Hornsea Project Four

Outline Design Plan TRACKED

Document Reference: F2.13

Revision: 02

Figure 2: HVAC OnSS and EBI Annotated Indicative Layout Scale (all heights identified are maximum design parameters).

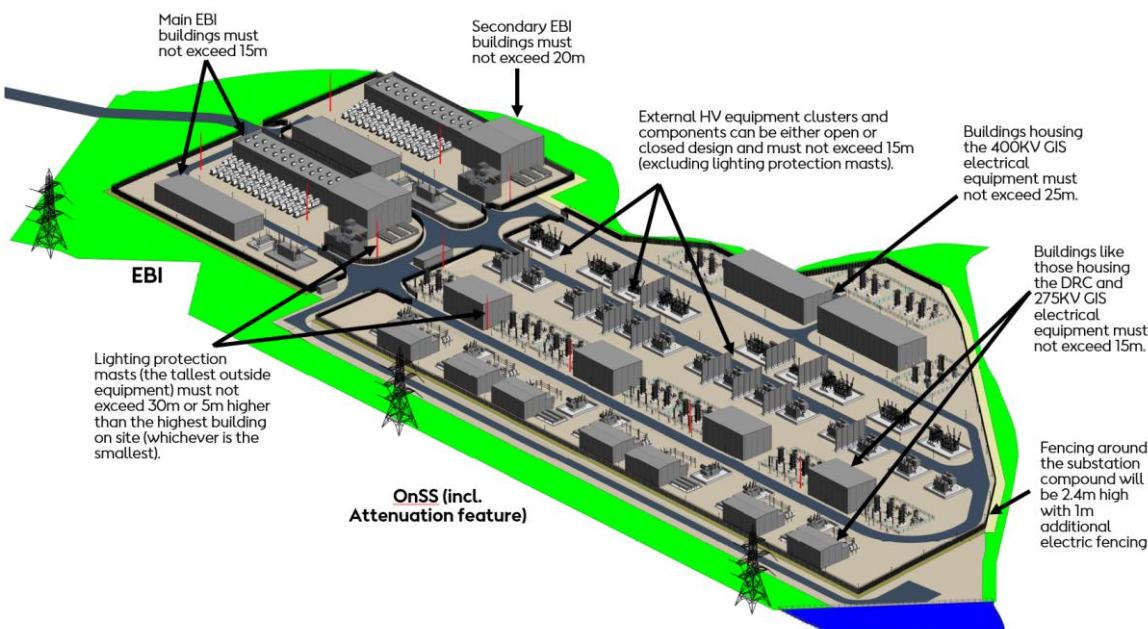
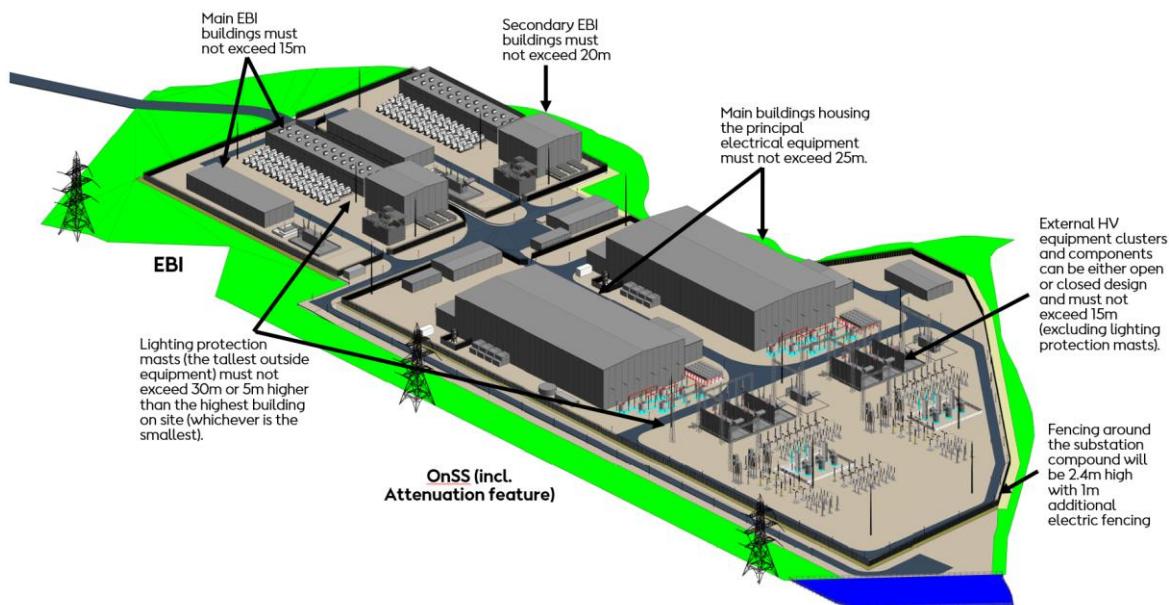
Rev	Page	Section	Description
01	N/A	N/A	Submitted as part of DCO Application
02	21	Figure 6	Amendment to Figure 6 specifying indicative colours in response to ISH2.
02	15	Table 3	Additional clarity regarding OnSS MDS to ensure consistency, further to clarification provided at Deadline 4.
03	13	6.2	Removal of word 'approximately' as set out in G1.6: OnSS and EBI Ground Levels Clarification Memo (AS-024).

- The area identified in the indicative HVAC and HVDC layouts for the OnSS (see [Figure 2](#) and [Figure 3](#)) is anticipated to be set at ~~approximately~~ 13.0m AOD – This is 2.5m above the maximum modelled flood extent for the 1 in 1,000 year plus climate change event and therefore inherently includes a significant natural freeboard .
- The area identified in the indicative HVAC and HVDC layouts for the EBI (see [Figure 2](#) and [Figure 3](#)) is anticipated to be set at ~~approximately~~ 14.5m AOD – This is 4.0m above the maximum modelled flood extent for the 1 in 1,000 year plus climate change event and therefore inherently includes a significant natural freeboard .
